EC 135
SERVICE BULLETIN
SB 135M-150-001

SPIFR GPS Navigation System – Modification of

Metro Aviation, Inc.			
1400 Airport Drive Hgr 120 Shreveport, La. 71107		Acft Model EC-135	Serial No. ALL
Date 22 SEPT 2004	Drawn by: UJ	Checked by: UJ	Approved by: UJ
Title: WIRING HARNESS INSTL		Detail: GPS RELAY WIRE UPDATE Sheet 1 of 1	
Dwg. No. 135M-153-E0-4	Page 2 of 2	Rev. No. IR	Scale: n/a
			Disk File: IFRSB01

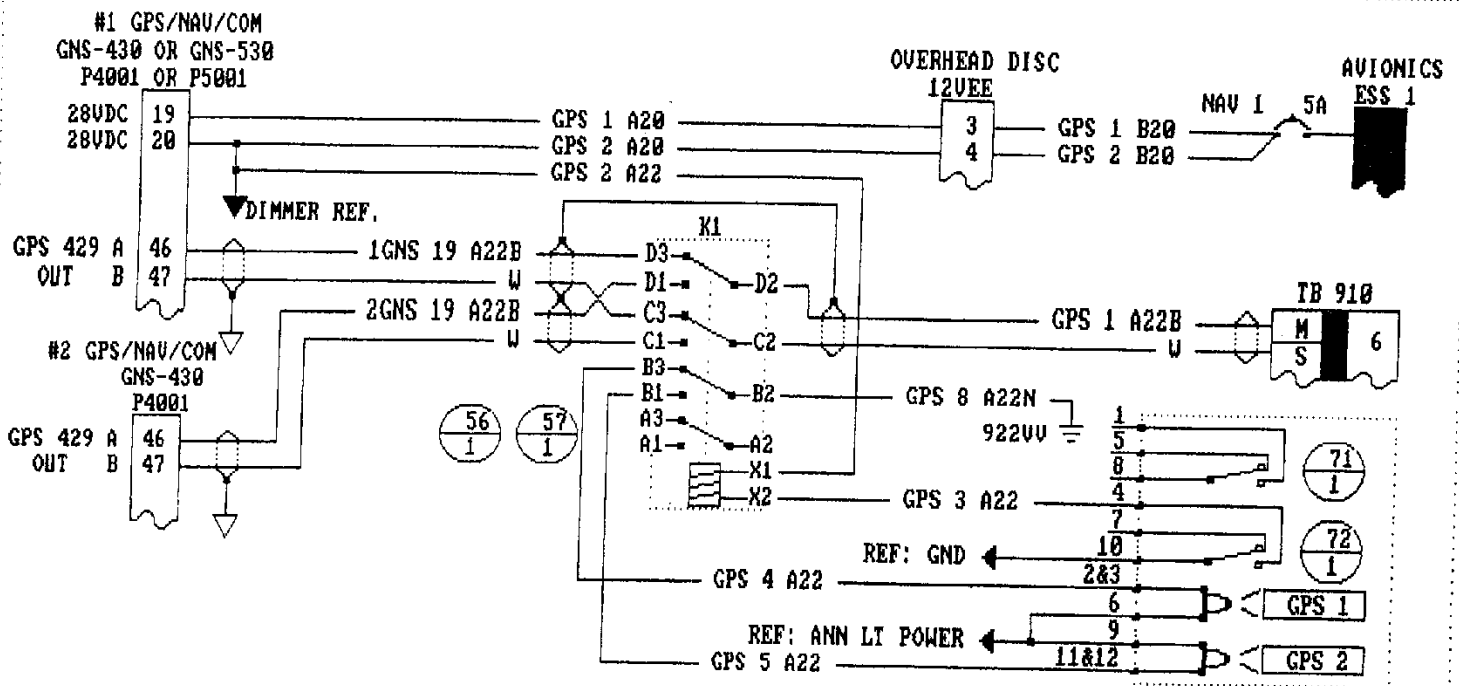
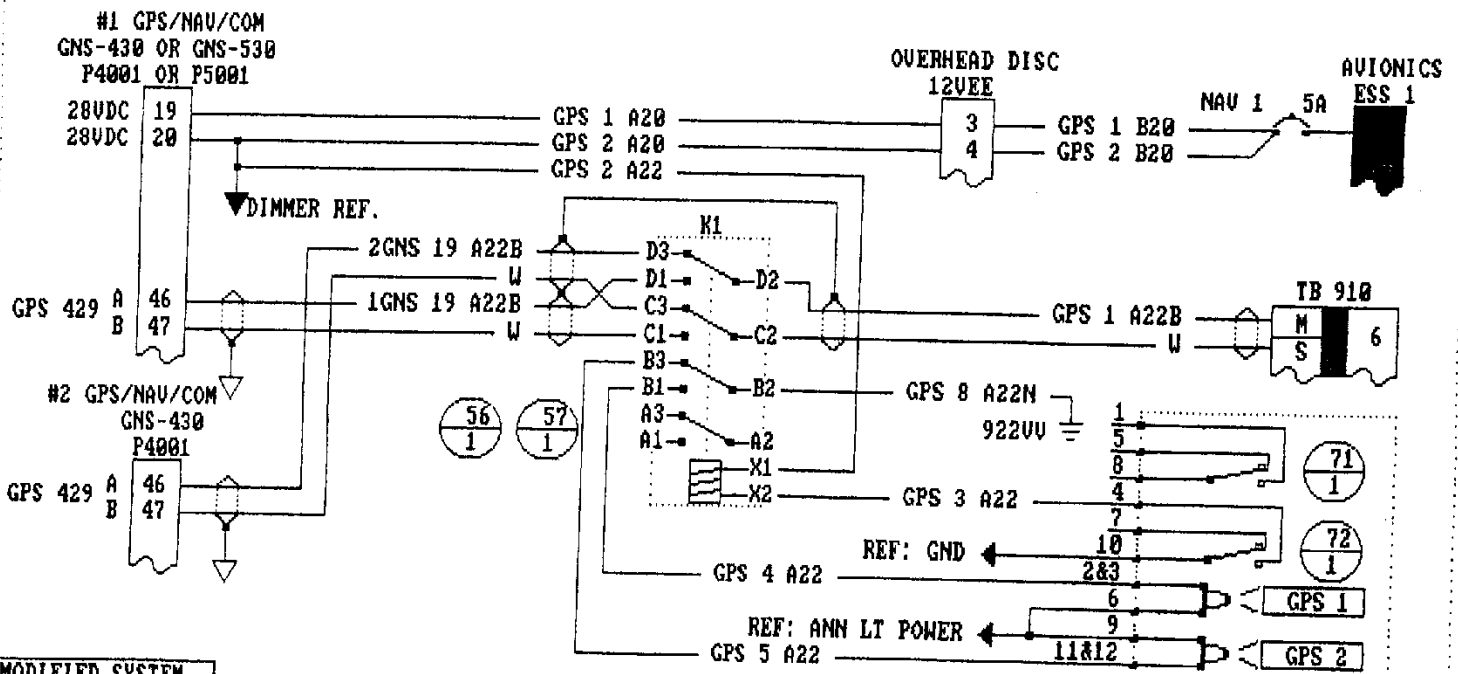
C. Reason: To ensure that GPS Navigation will be provided to the Pilot SMD-45 ND (Navigation Display) whenever power is lost to the #1 GPS/Nav/Com and or K1 relay. VOR Navigation not effected.

D. Description: Relocating wiring on the GPS data switching relay K1.

REASON: IT HAS BEEN FOUND THAT IF A LOSS OF POWER TO THE K1 GPS DATA RELAY AND THE #1 GPS/NAV/COM SYSTEM THERE WOULD BE A LOSS OF GPS DISPLAYED INFORMATION ON THE PILOT NAVIGATION DISPLAY (SMD-45 ND). FULL GPS AND VLOC NAVIGATION IS STILL AVAILABLE ON THE REMAINING #2 GPS/NAV/COM SYSTEM WITH VLOC INFORMATION STILL PRESENTED ON THE PILOT ND. THIS IS A MODIFICATION TO ELIMINATE THIS ISSUE.

- MODIFICATION:
- 1- LOCATE K1 RELAY ON AVIONICS SHELF.
 - 2- REMOVE RELAY FROM SOCKET.
 - 3- EXTRACT THE FOLLOWING WIRES:
1GPS 19 A22B-W
2GPS 19 A22B-W
GPS 4 A22
GPS 5 A22
 - 4- REINSTALL WIRES IN K1 RELAY SOCKET AS SHOWN ABOVE IN MODIFIED SYSTEM DRAWING.
 - 5- REINSTALL RELAY AND FUNCTIONALLY TEST GPS SYSTEMS OPERATION WITH SMD-45 DISPLAY SYSTEM.

1GPS 19 A22 White/Blue in D1

1GPS 19 A22 White in C1

2GPS 19 A22 White/Blue in D3

2GPS 19 A22 White in C3

GPS 4 A22 in B1

GPS 5 A22 in B3
